**Subject: Soil and Groundwater Sampling Plan and Closure Plan, Intake and Discharge  
Tunnels, Former Seabreeze Yacht Center, Oakland, California**

# SOIL AND GROUNDWATER SAMPLING PLAN AND CLOSURE PLAN INTAKE AND DISCHARGE TUNNELS

RE: Seabreeze Yacht Center, Comments on the Report "Project Manual and Plan Drawings and Soil and Groundwater Sampling Plan and Closure Plan, Intake and Discharge Tunnels, Former Seabreeze Yacht Center, Oakland" April 19, 2001

PROPOSED GRAB SOIL AND GROUNDWATER SAMPLING LOCATION

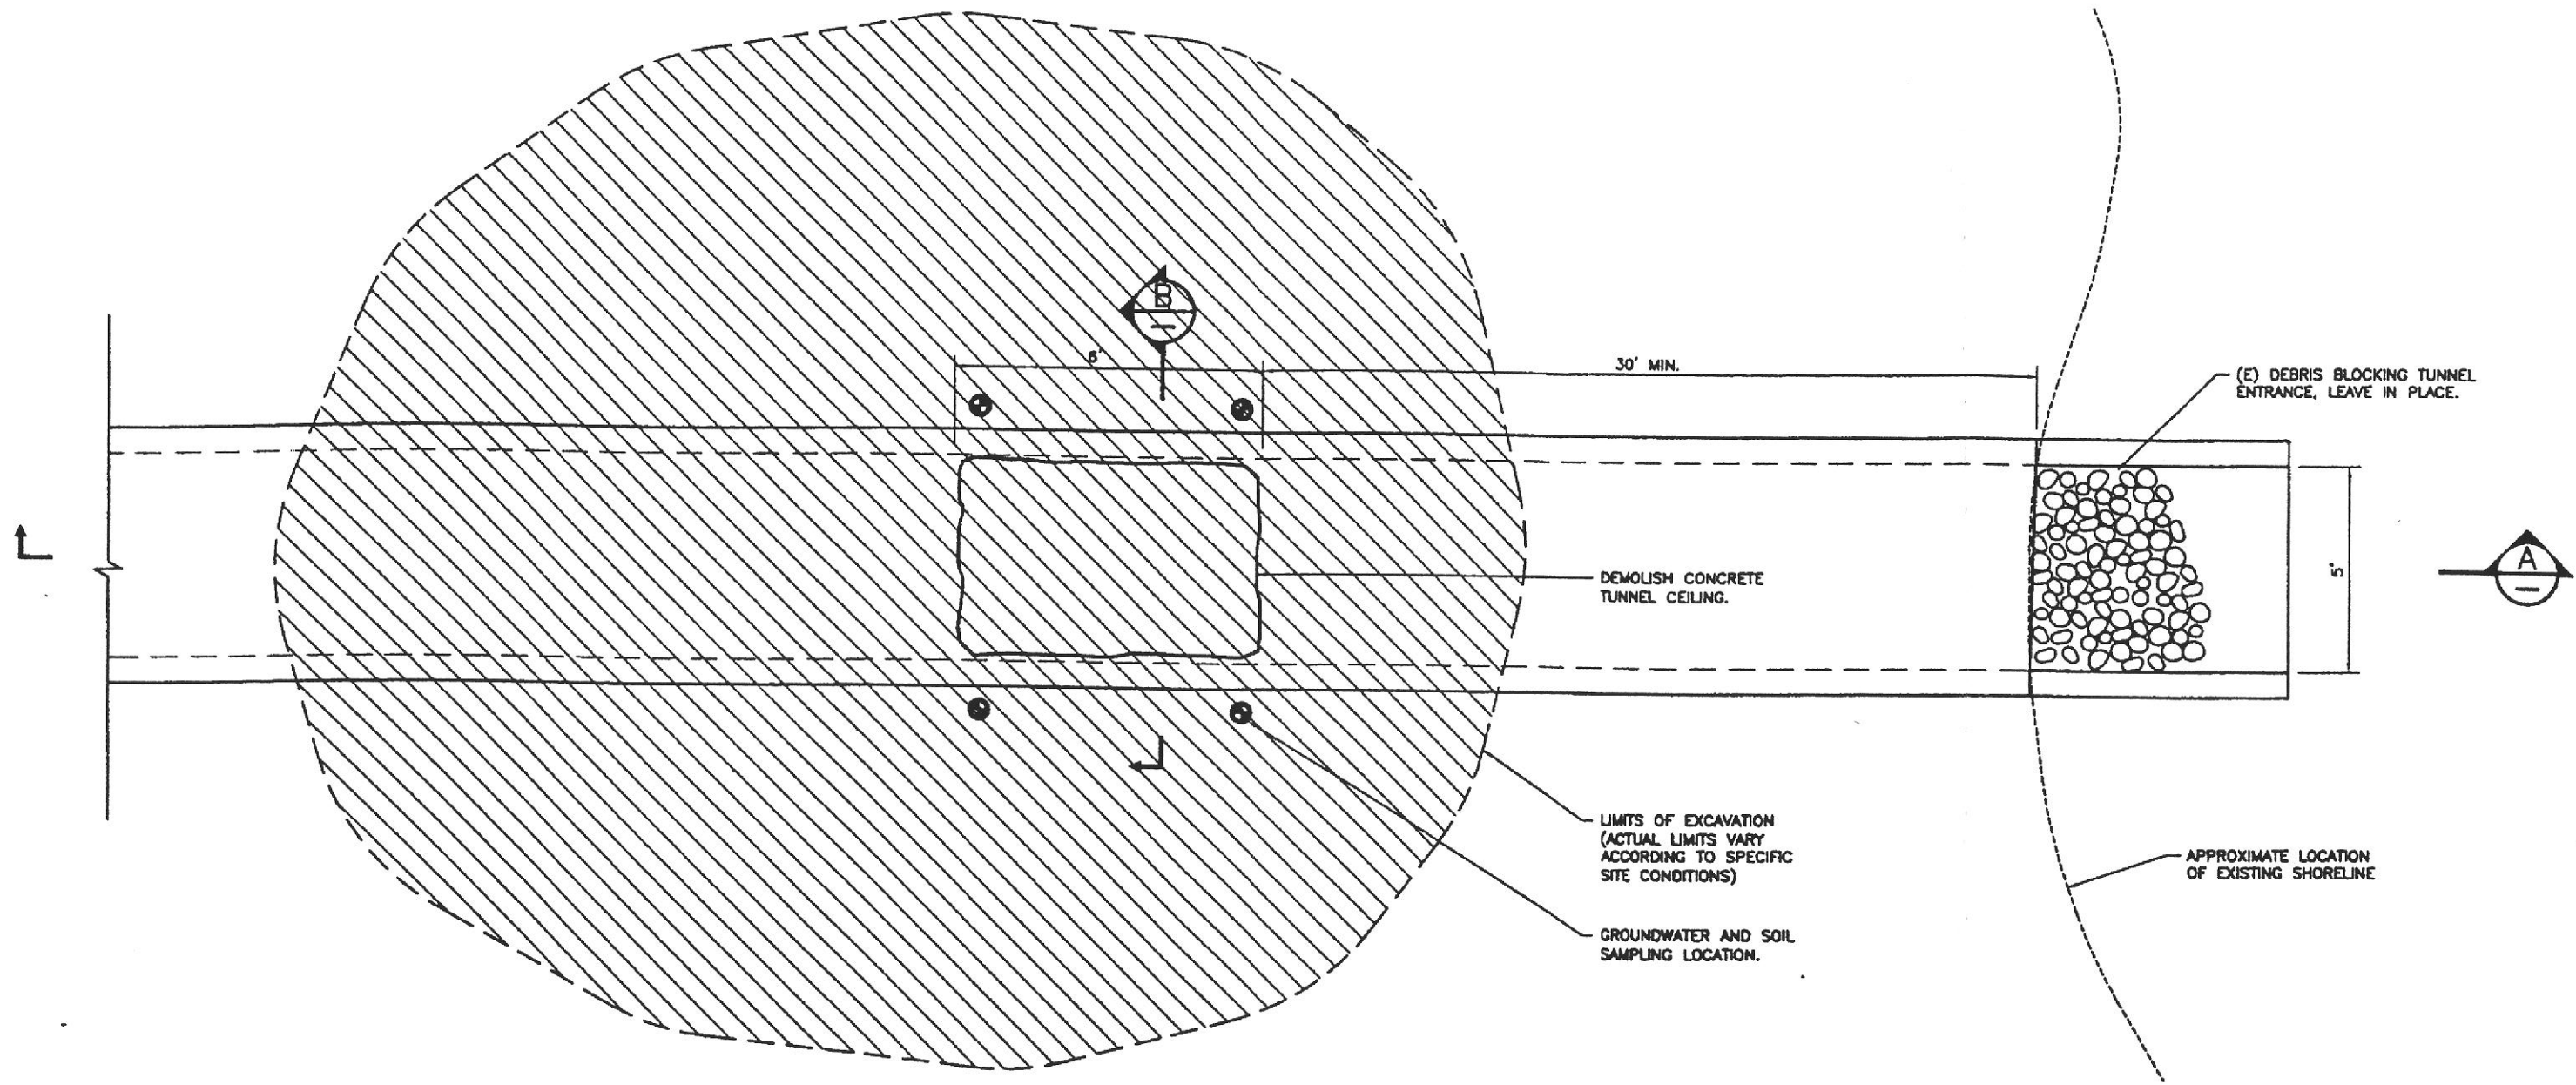
*is this right?*

Should treat intake & dischg area separately

this is not appropriate
